ADDENDUM NO. 2

**ITB 25-FAC-0017 – Building Improvements @ Dwight D. Eisenhower School
3700 Tall Pines Drive
New Orleans, LA 70131**

Architect's Project No. M25-001

For Owner: Orleans Parish School Board

1
A-3.2
EXIST PLAN VIEW OF RAMP @ KITCHEN
SCALE: 3/8"=1'-0"

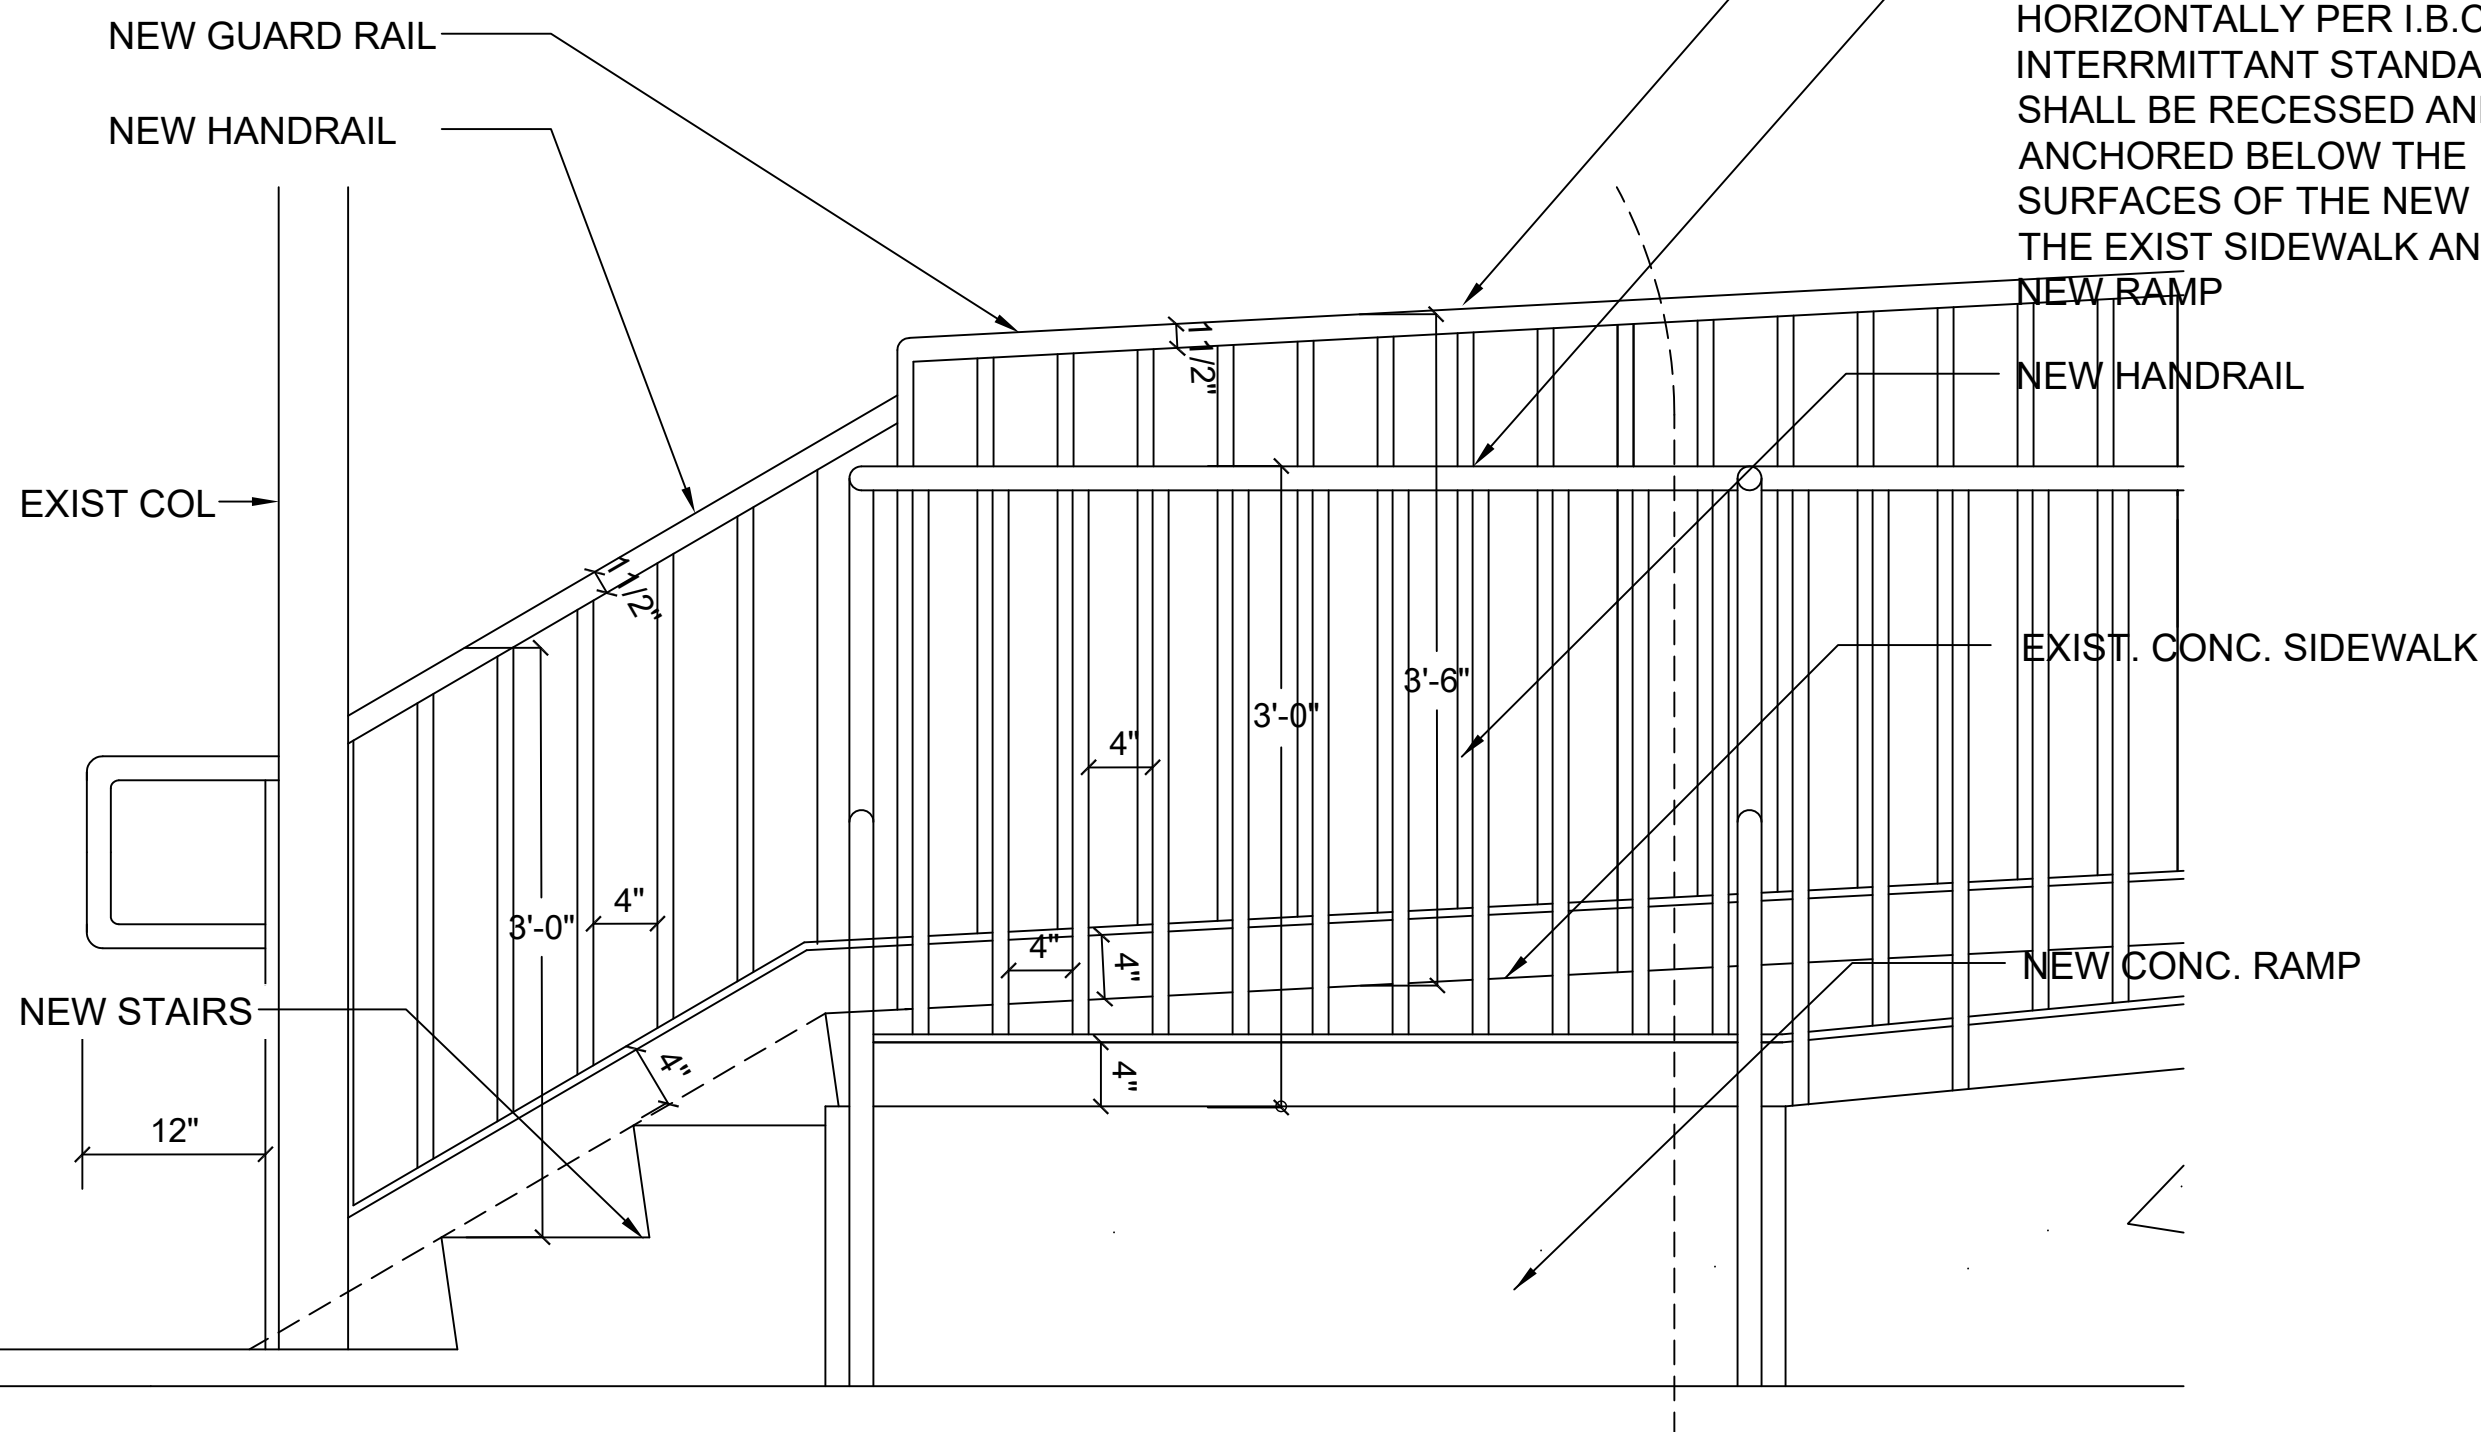
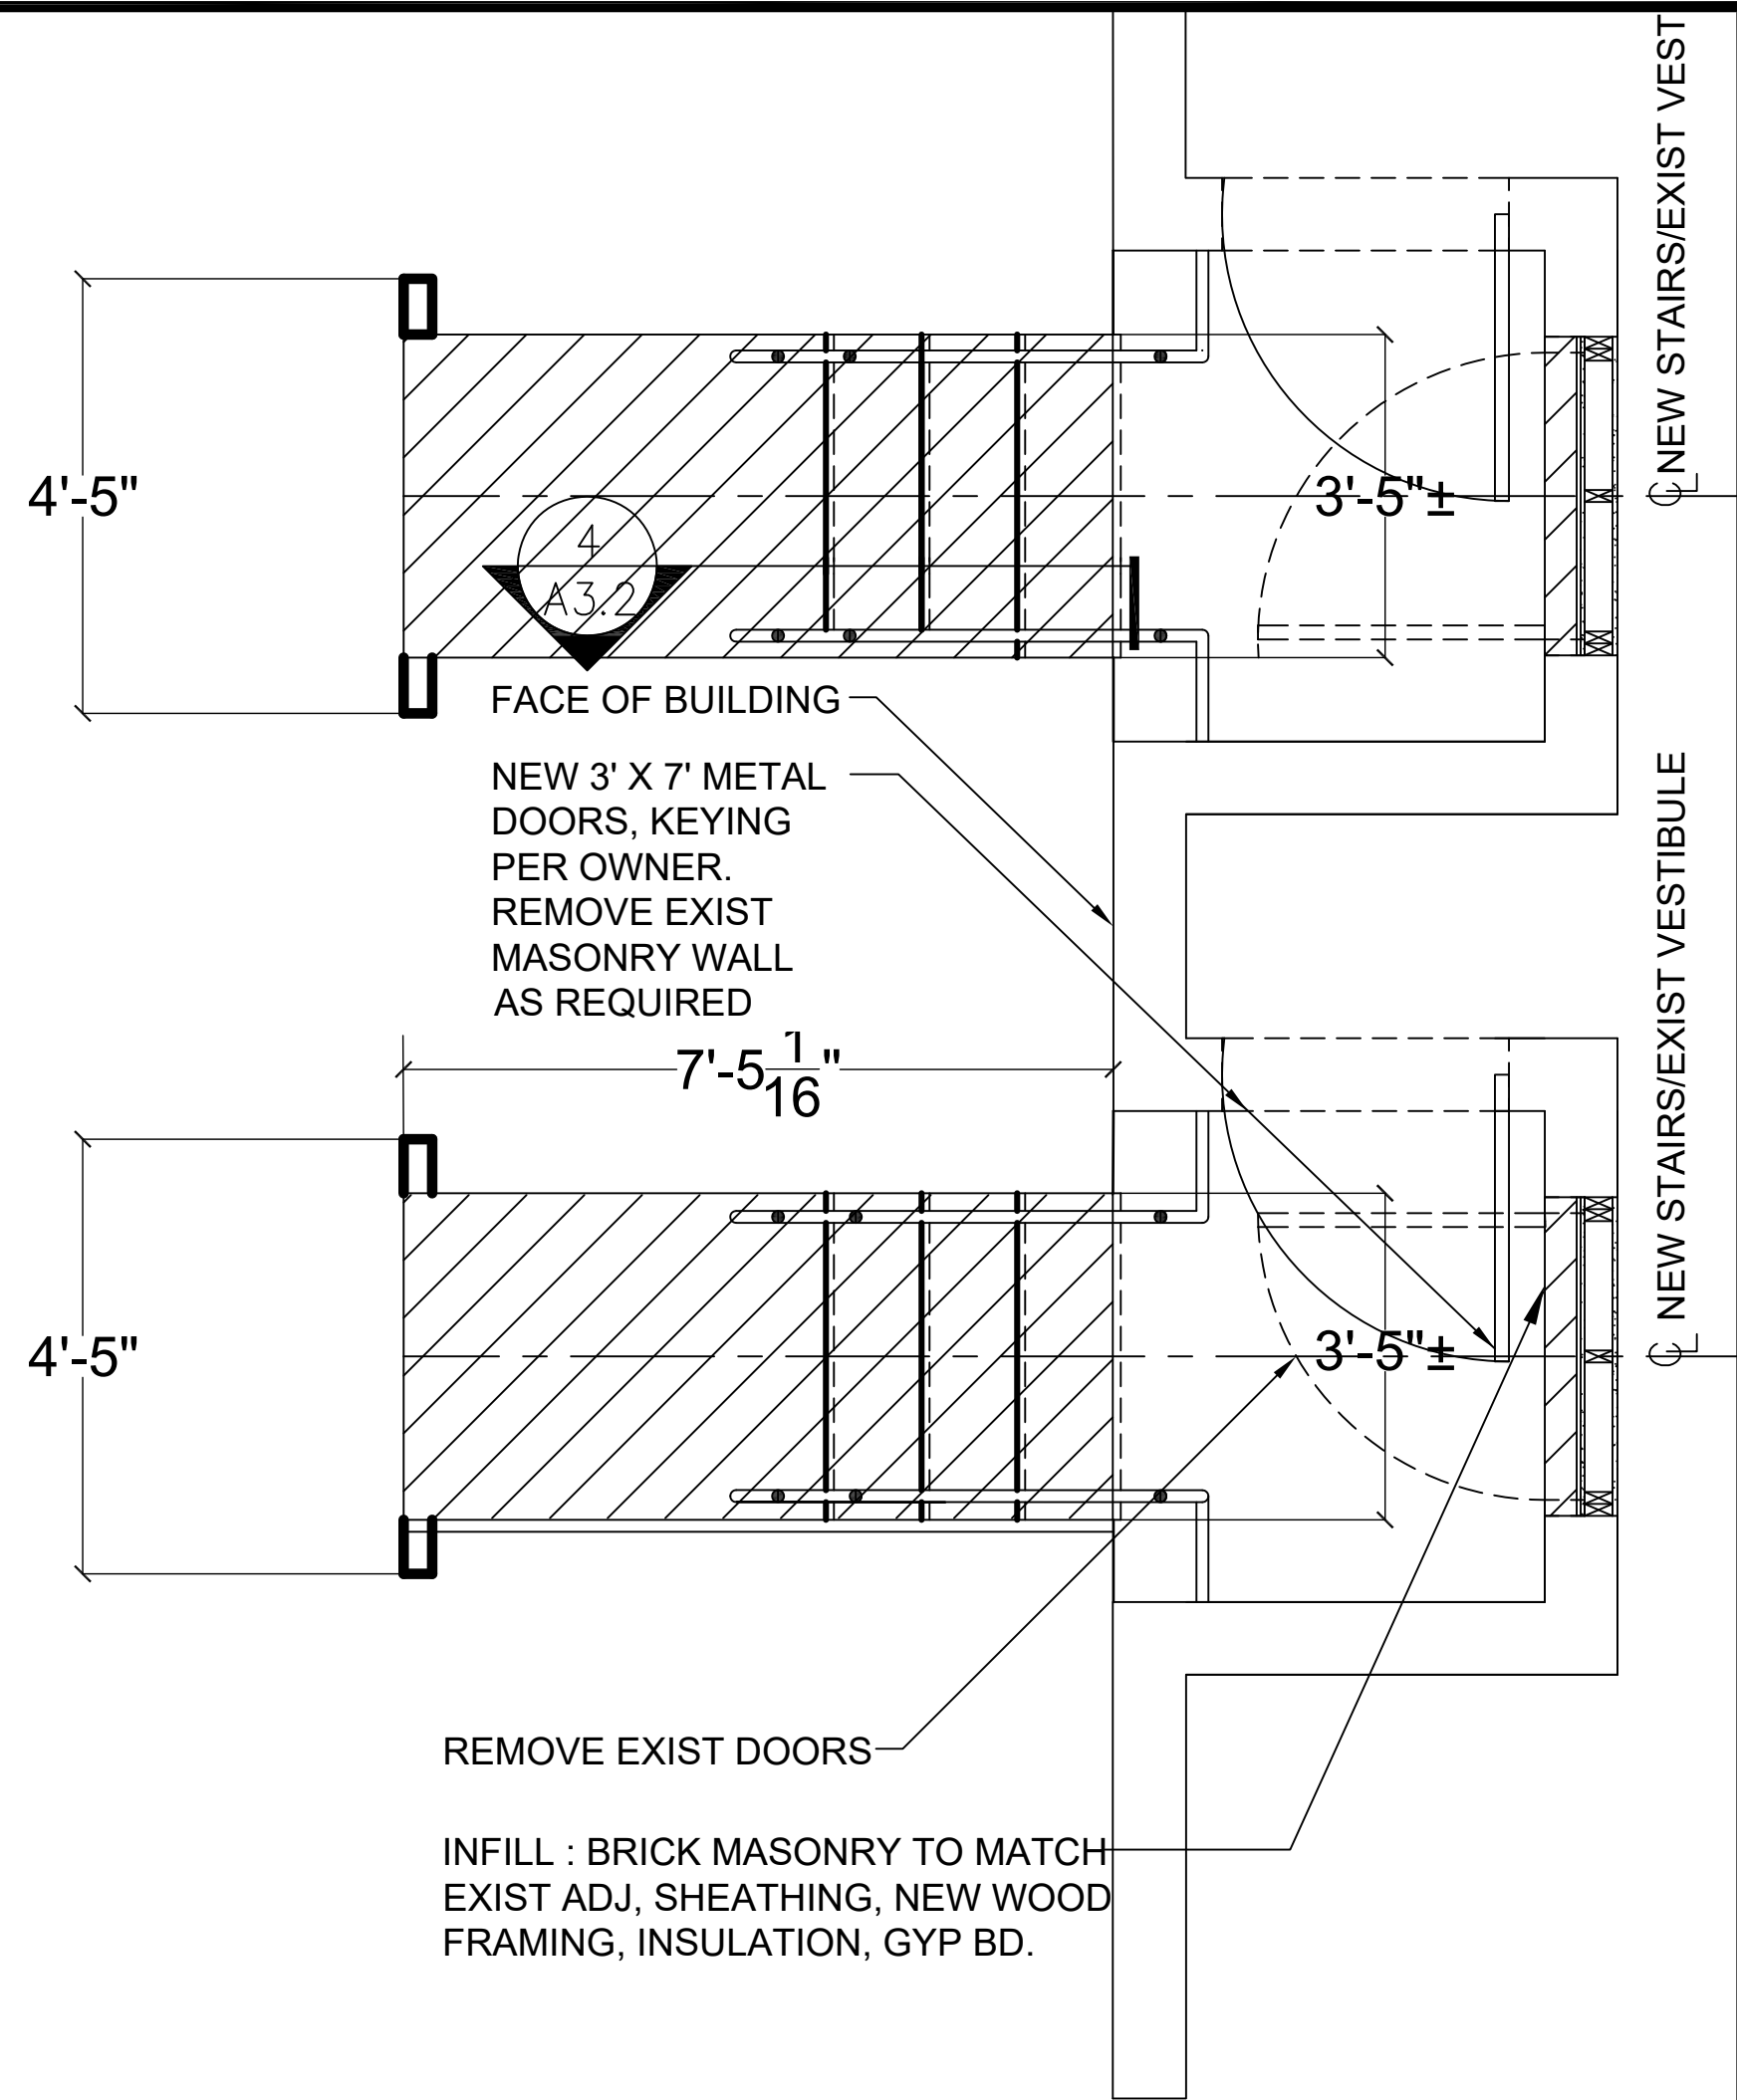
4. Question: Can you confirm the total length of railing to be installed?

Answer: We did a quick tally, but these numbers are not to be used in lieu of the bidder's own tally of what we show in the construction documents. 36" handrailing: 169'-0", 42" guard railing: 160'-4.1/2".
